**MEMORANDUM**

TO: Planning, Housing, and Economic Development (PHED) Committee

SUBJECT: Veirs Mill Corridor Master Plan—fiscal impact statement, evaluation of transportation adequacy at buildout; transportation elements

Figure 1, Vision Zero Concept with grade separation at Veirs Mill and Randolph, looking South from the North Corner (base map aerial view credit: google maps).

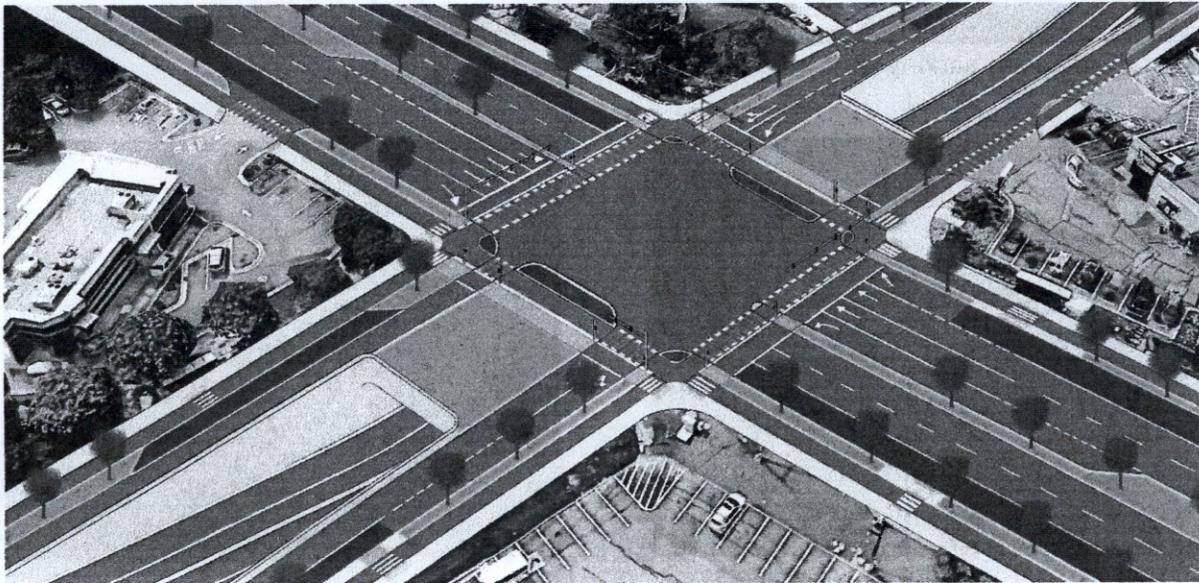
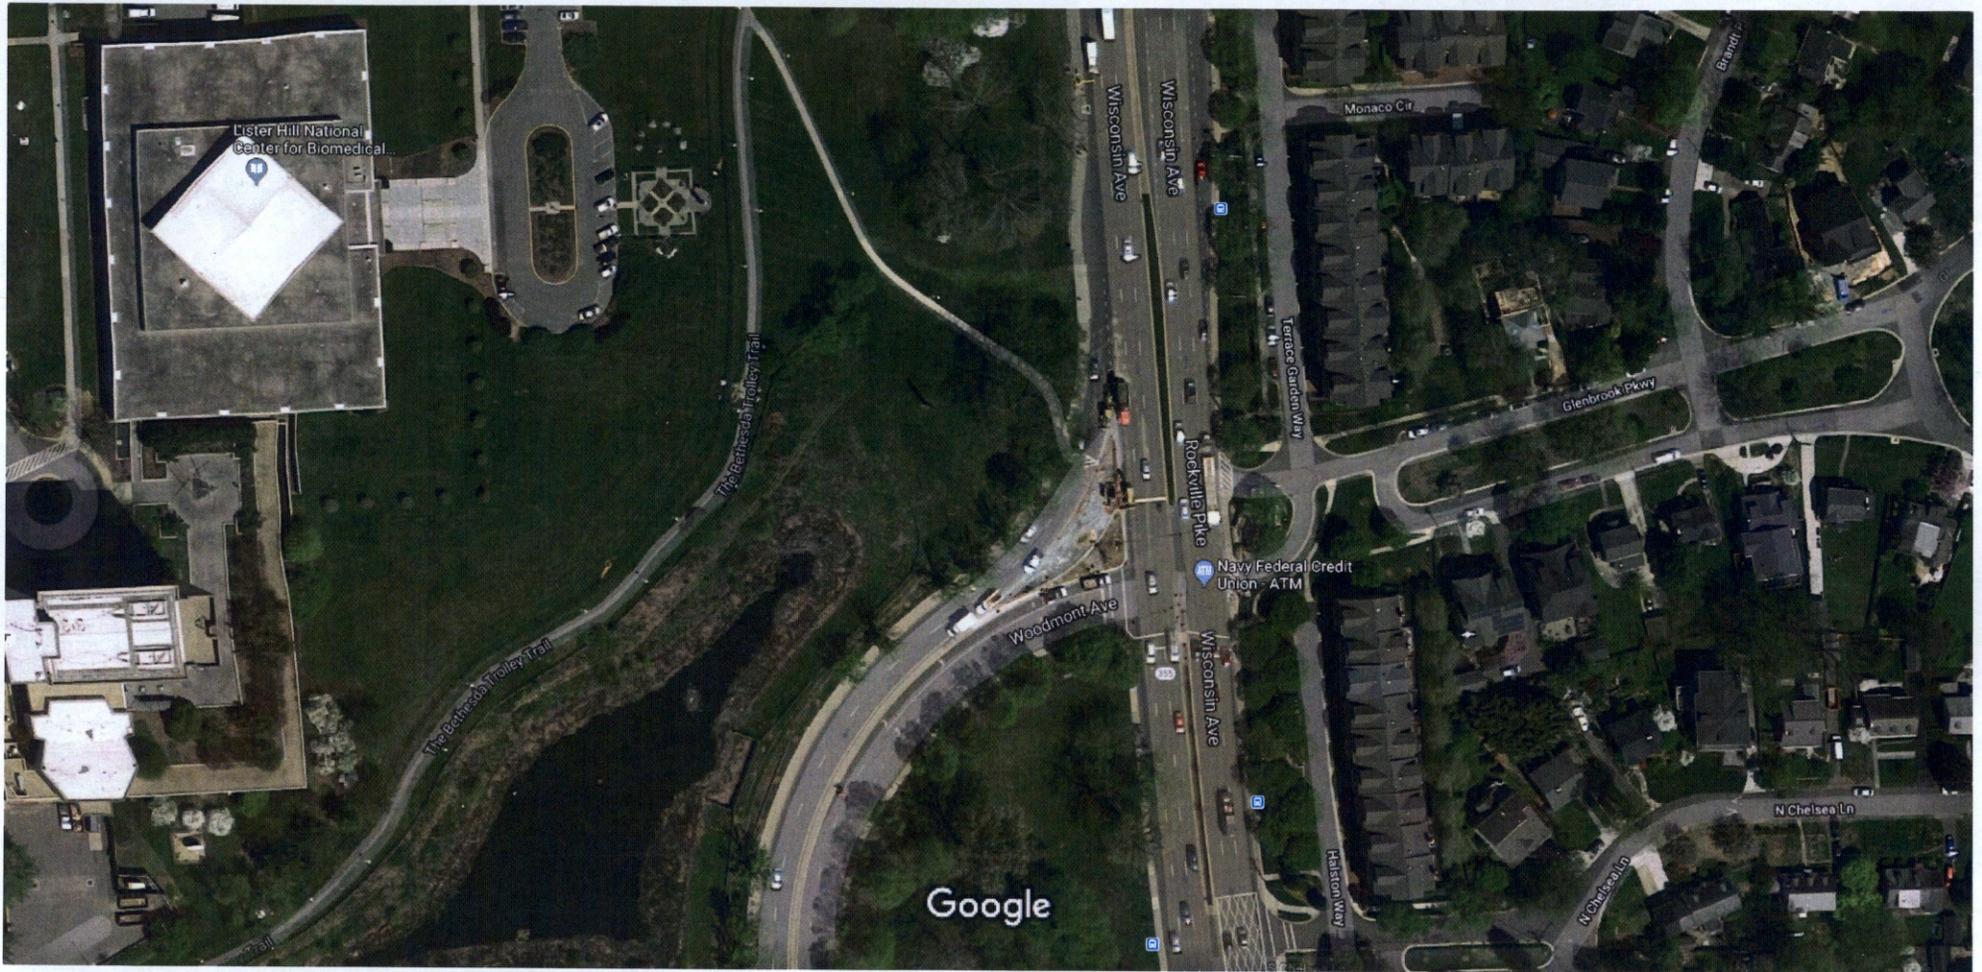
For your consideration, is an alternative to the Veirs Mill Corridor Plan's recommendation to eliminate the proposed grade separation at Veirs Mill Rd. and Randolph Road from the 2004 Master Plan of Highways and Transitways. The plan on page 54 states "A grade-separated interchange at this intersection is inconsistent with the overall transportation goals of this plan, which seek to improve conditions for pedestrians, bicyclists and transit users on Veirs Mill Road and the surrounding communities". We wish to challenge this premise and demonstrate a grade separation design that is consistent with the plan's objectives and provides a superior solution than the status quo for all stakeholders.

Figure 18 from the corridor plan illustrates features of road treatments and alignments conceptually. However, it fails to illustrate how these features would be applied at the scale of the real intersection at Veirs Mill and Randolph. Therefore, we submit the following:

This conceptual design incorporates the intersection treatments consistent with a protected intersection design. It provides for: countdown signals, high visibility crosswalks, pedestrian refuge islands, physical barriers separating bicycle lanes, curbed extensions protecting bicycle and pedestrian crossings, and dedicated lanes for transit. It is consistent with the lane alignments for Veirs Mill Road illustrated on Figure 13 from the corridor plan. Also, due to the grade separation, which eliminates Randolph thru traffic from light timing considerations, the number of left turn lanes from Veirs Mill road can likely be reduced to one lane for each turn as recommended in section 2.5.3: Street Network Recommendations. With incorporation of pedestrian refuge islands, the maximum number of lanes for a pedestrian to cross is reduced to a maximum of four.

We respectfully request that this design be included in the plan in some fashion, if at the very least as an alternative intersection recommendation.
